PLANNING & ZONING COMMISSION MAY 2023

B. New Construction Approval 0710 Whispering Pines

TO: Michelle Eddy, CMC/CPM - Town Manager/Clerk
 FROM: Kyle Parag, Plan Reviewer - CAA
 DATE: April 25, 2023
 RE: Planning/Zoning/Architectural Guidelines review –
 710 Whispering Pines

SITE PLAN

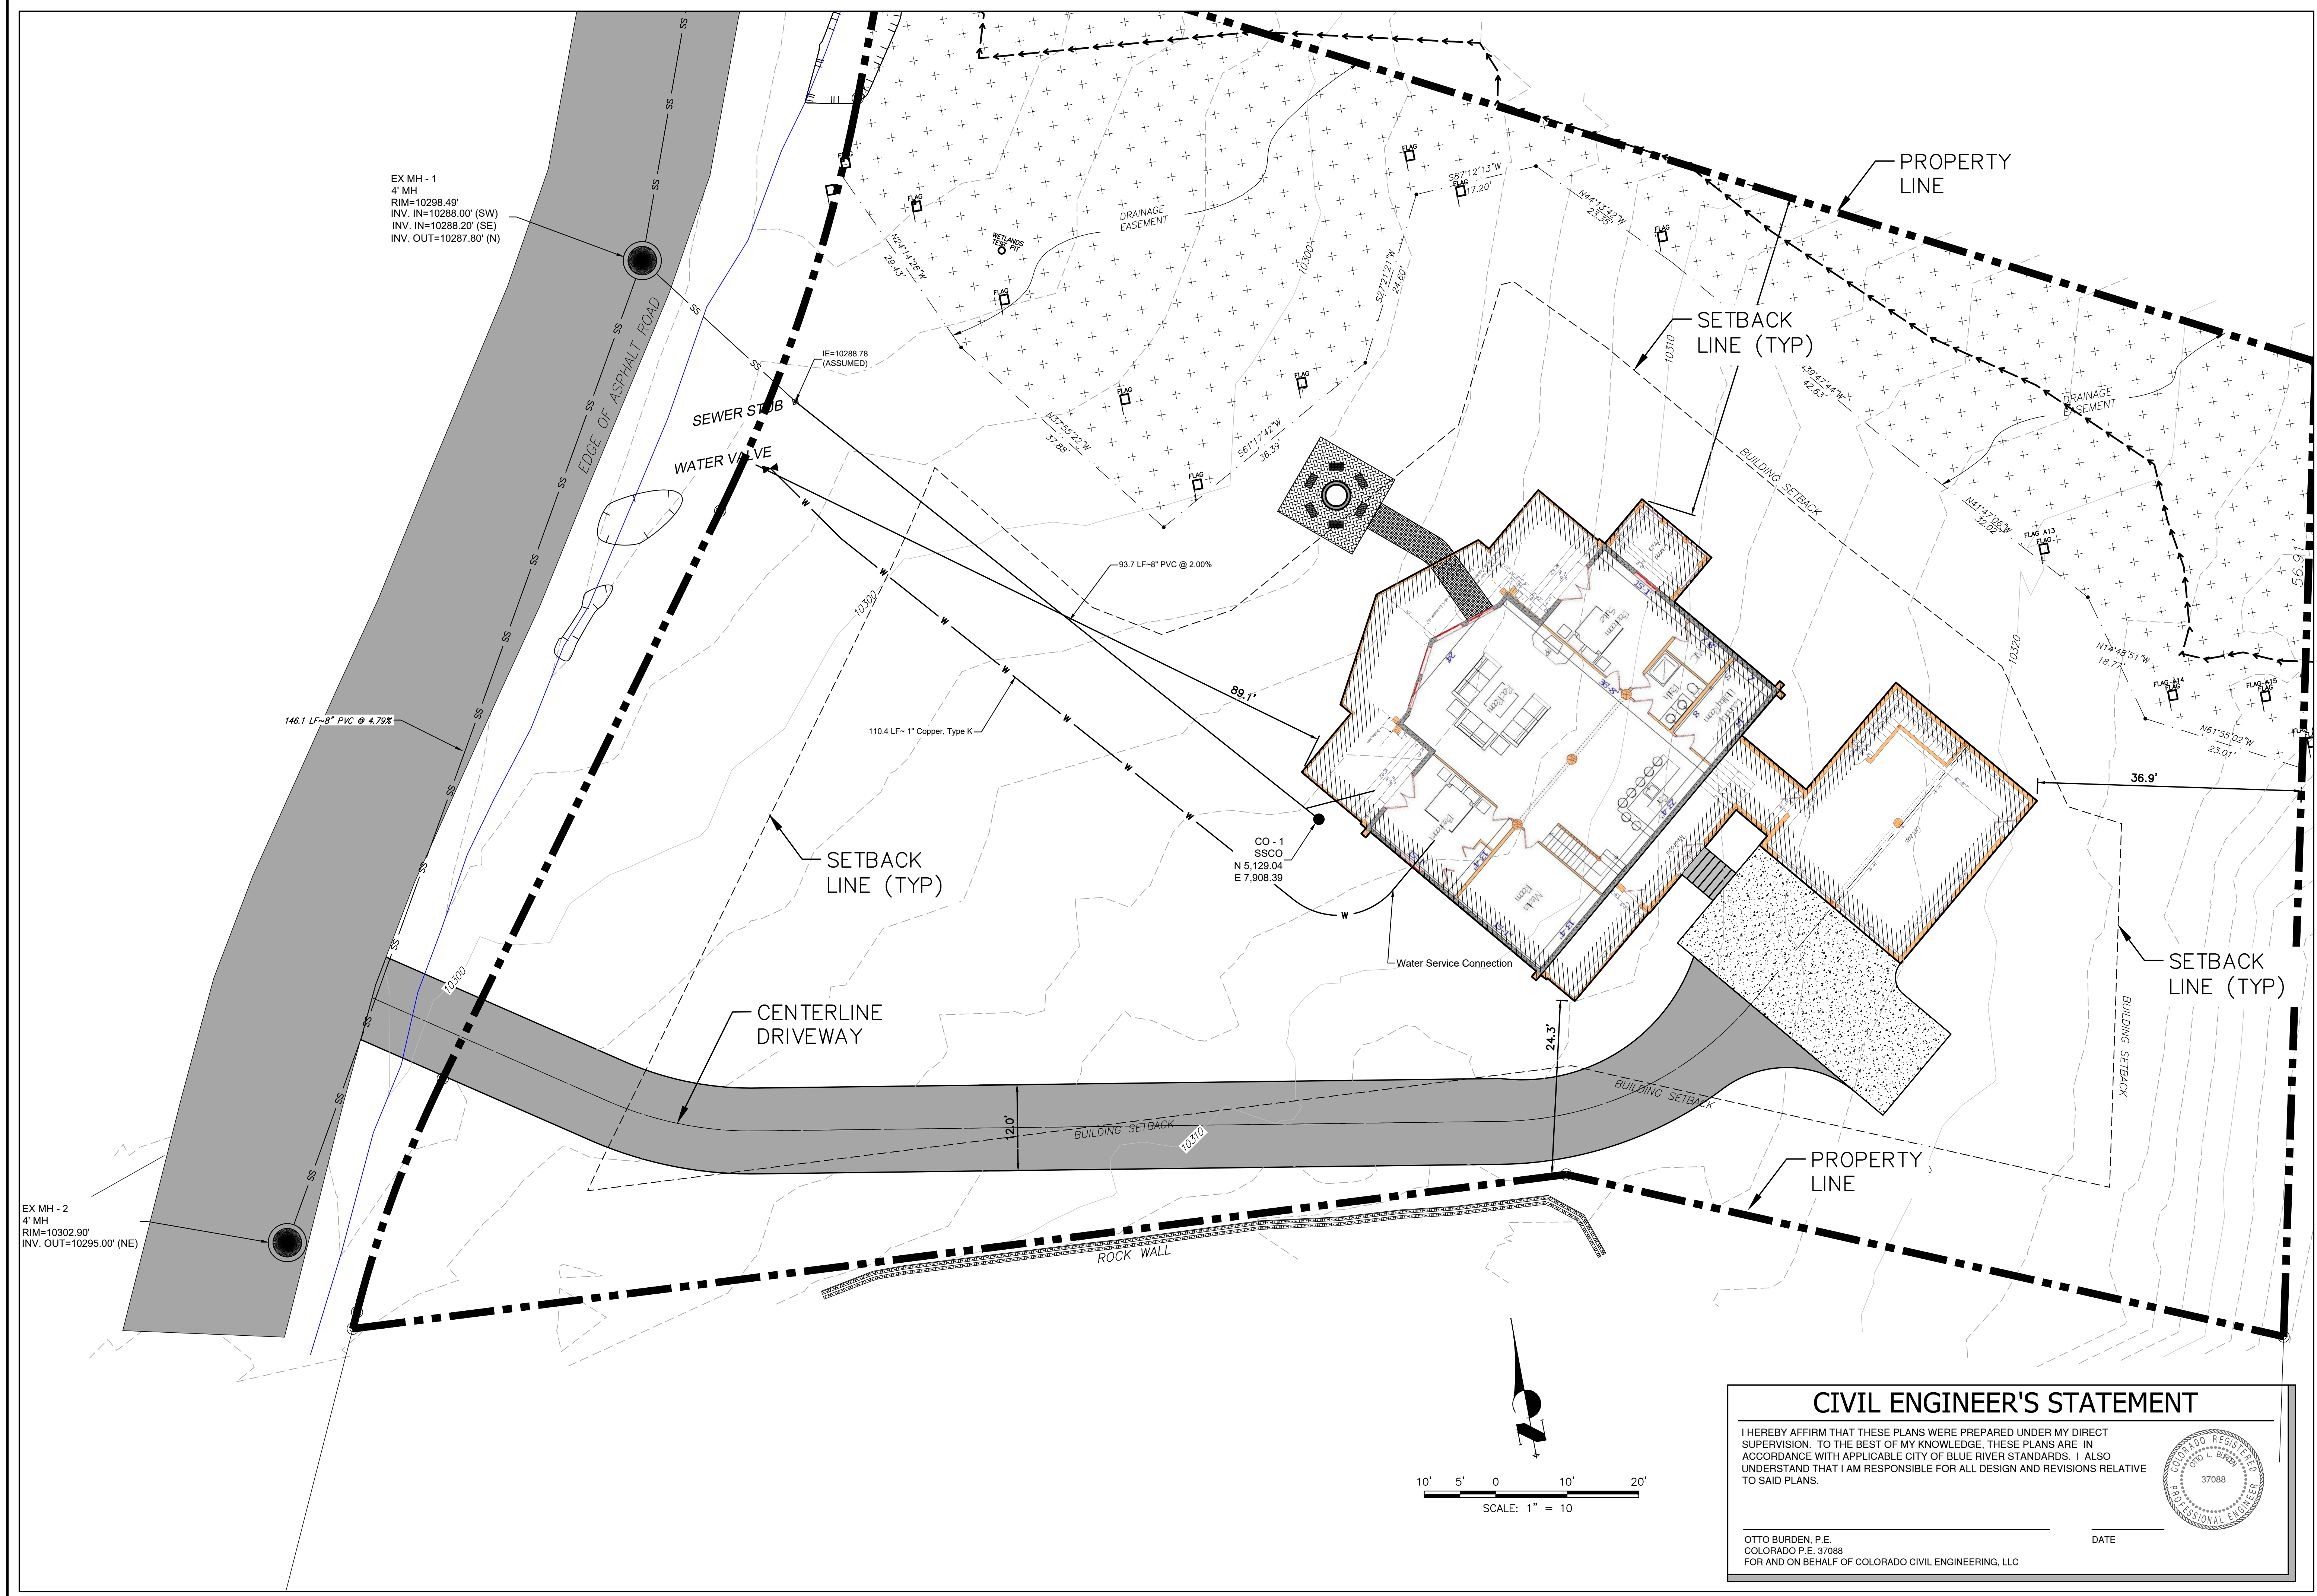
STANDARD	NOTES/REMARKS	SUBSTANTIAL COMPLIANCE
DEVELOPMENT STANDARD		
VI. B. Building Envelope	The proposed principal residence is properly sited within required setbacks. The submitted site plan depicts compliance.	Y
VI. C. Building Siting	Structure is proposed in context with natural drainage patterns, contours, and landforms. The moderate sloping property will be leveled off for the footprint of the home, and will create the maximum 2:1 slopes at the rear of the property.	Y
VI. D. Grading and Drainage	Final grading is proposed to avoid unnaturally broad, flat surfaces. Maximum 2:1 slopes are proposed. Construction area is proposed to extend onto the National Forest land to achieve the slopes. Permitting from National Forest will be required.	Y

VII. C. Setbacks	The proposed structures sit within the required setbacks per the submitted site plan.	Y
VII. D. Building Height	Building height is indicated at 34' 9" but is not measured according to Blue River definitions. The actual height is indicated is estimated at 35'6" which is non-compliant. More information or possible modifications will be required to be made in subsequent reviews to correctly verify the height.	
VII. E. Roofs	Roof design is gabled and relatively simple. Roof material is black asphalt shingles	Y
VII. F. Exterior Wall Materials	Exterior walls are log with a driftwood color stain that has a natural appearance.	Y
VII. G. Exterior Trim	Trim colors are not clearly indicated but look to be darker than the wall color.	
VII. H. Windows and Doors	Windows, doors, and garage doors are proportional to the structure and appear in general compliance. A large window wall is proposed on rear of home.	Y

Front Elevation

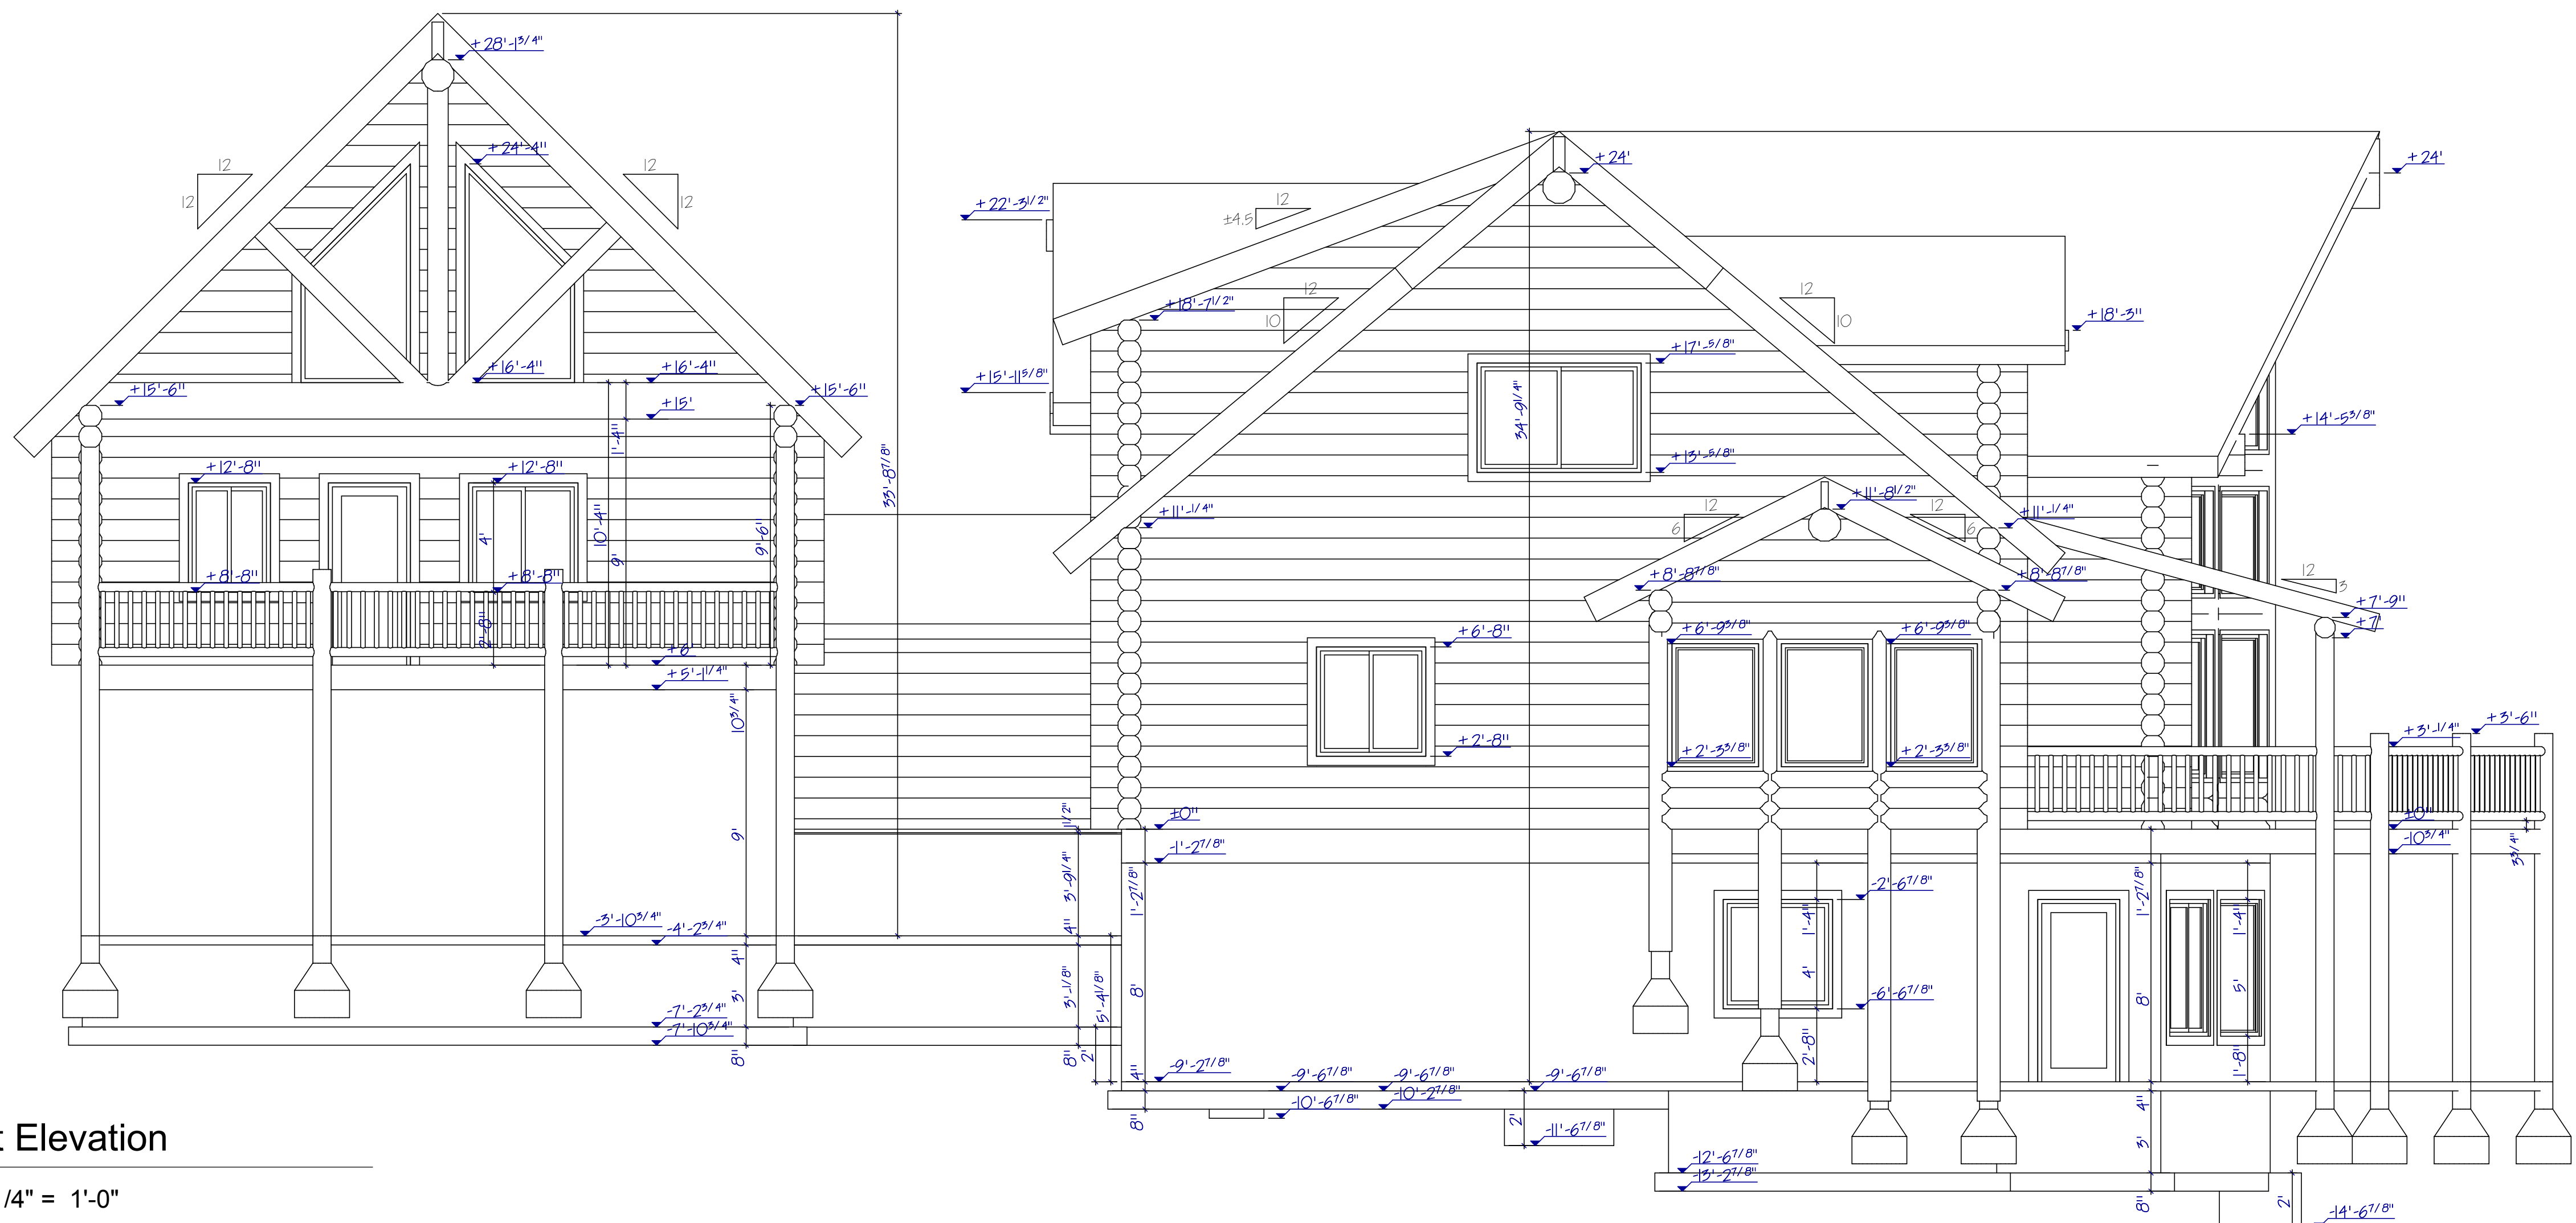
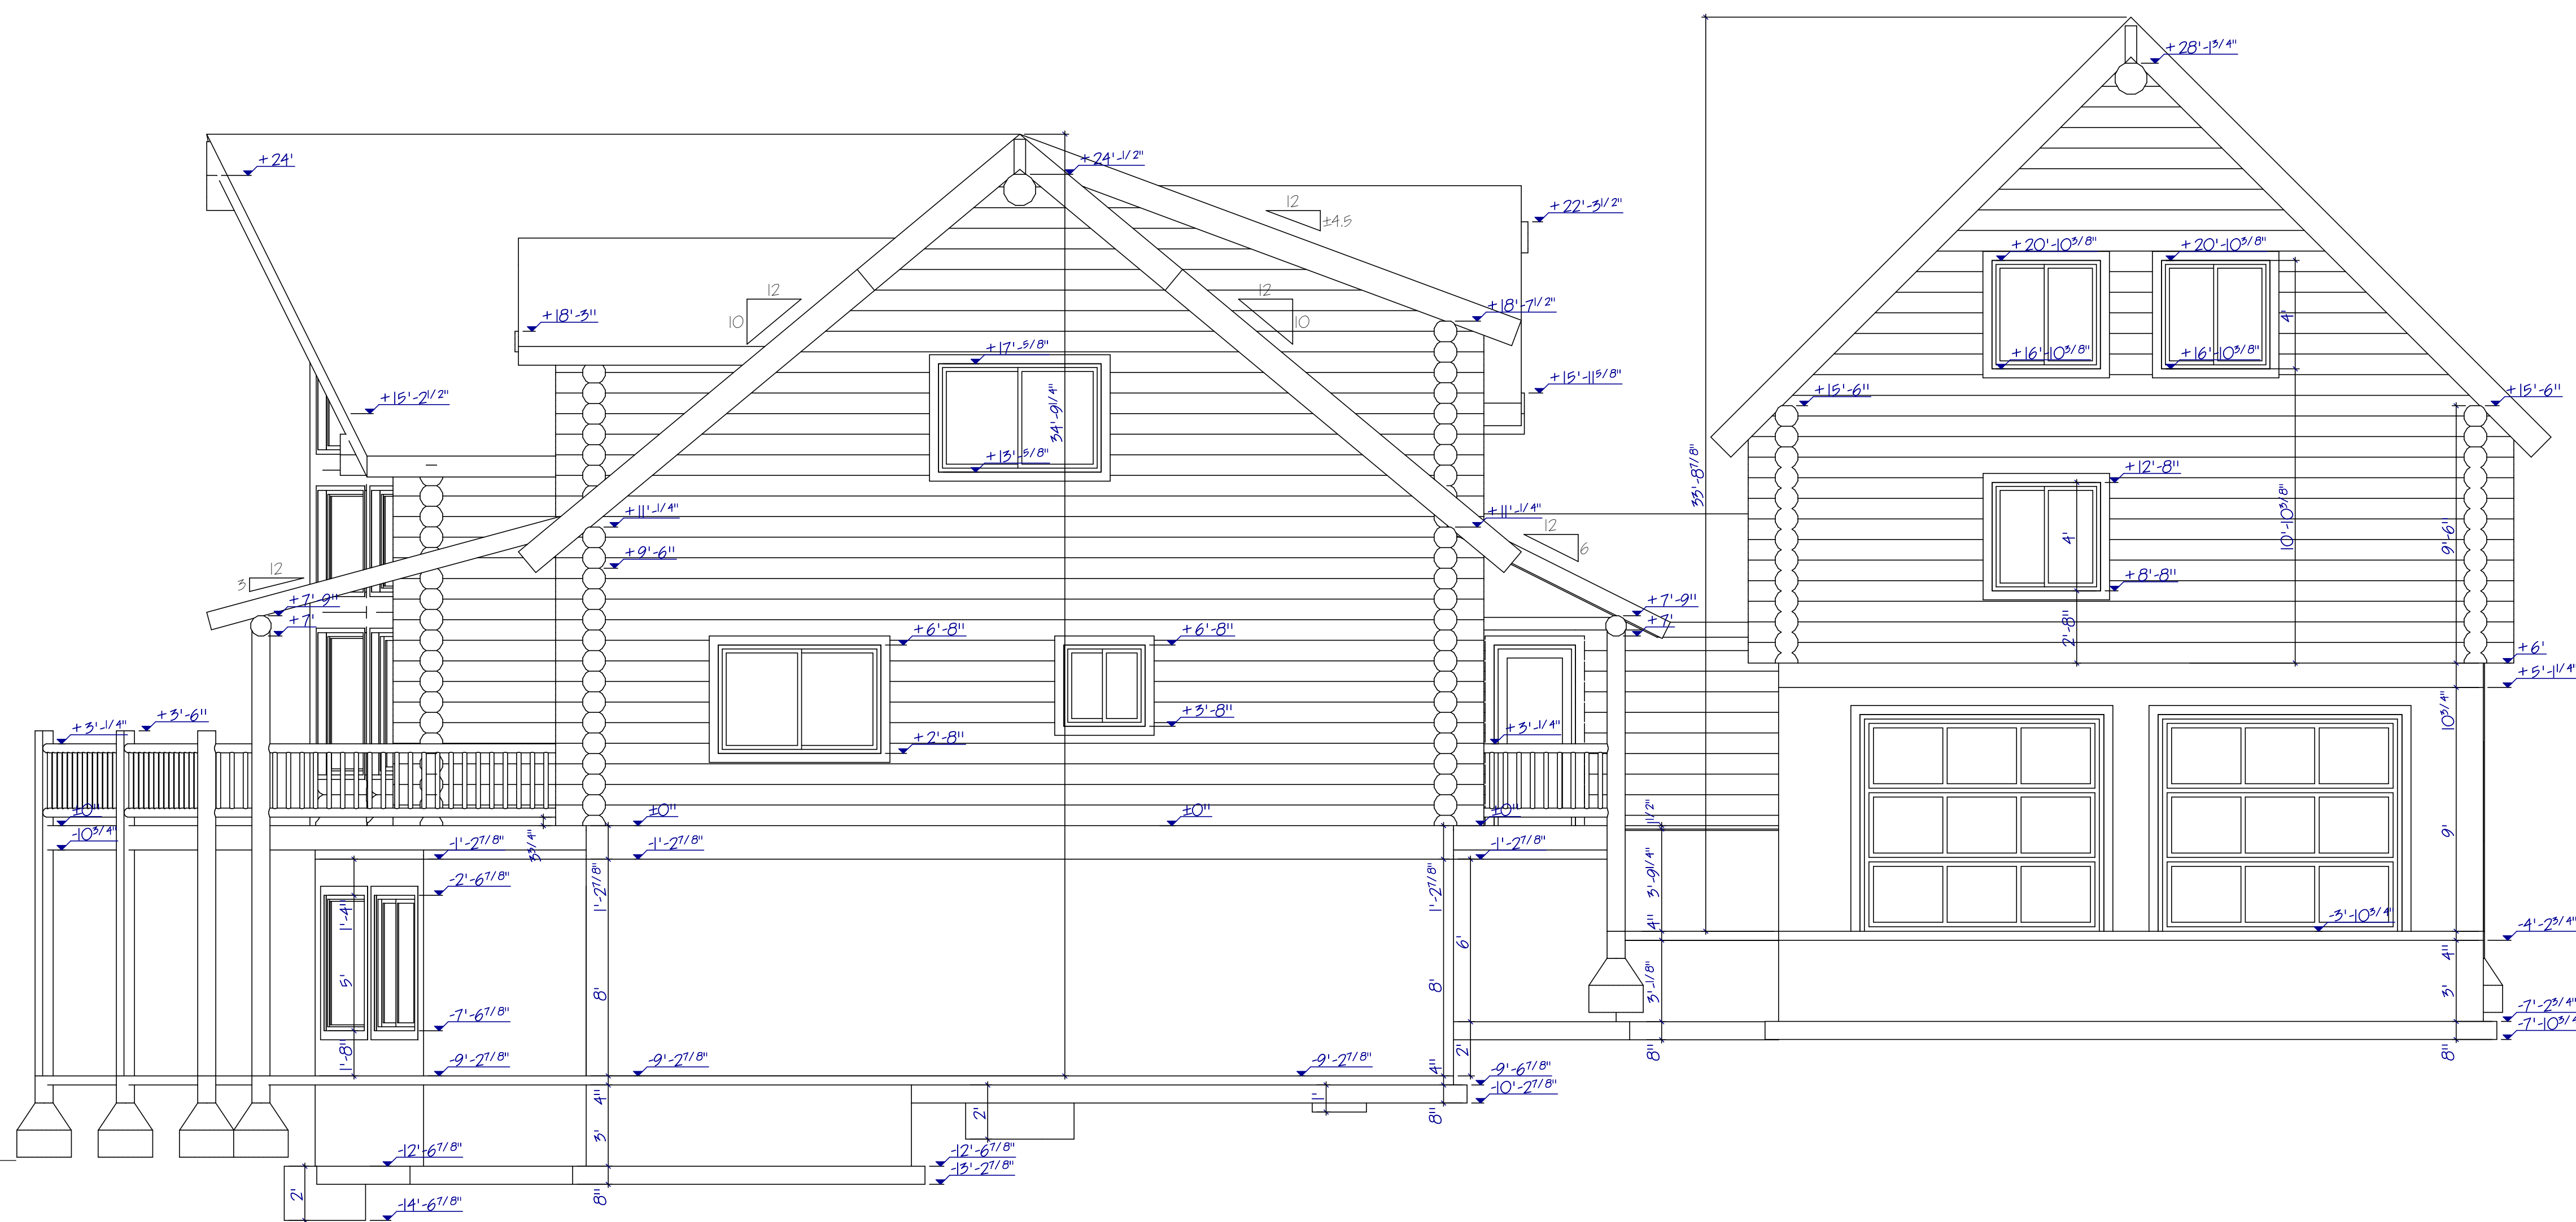
VII. I. Balconies and Railings	Railings are substantial in appearance and consist of vertical and horizontal wood.	Y
VII. J. Chimneys and Roof Vents	Fireplace is drawn on the floor plans, but not indicated on the exterior elevations. Expectation of a significantly sized chimney.	
VII. K. Exterior Colors	Proposed colors indicated on the color board are in general conformance. Colors are natural wood colors, with brown/wood colors for stone and posts.	Y
VII. L. Solid Waste Collection and Service Areas	Trash and storage areas are not indicated.	Y
SITE ELEMENTS
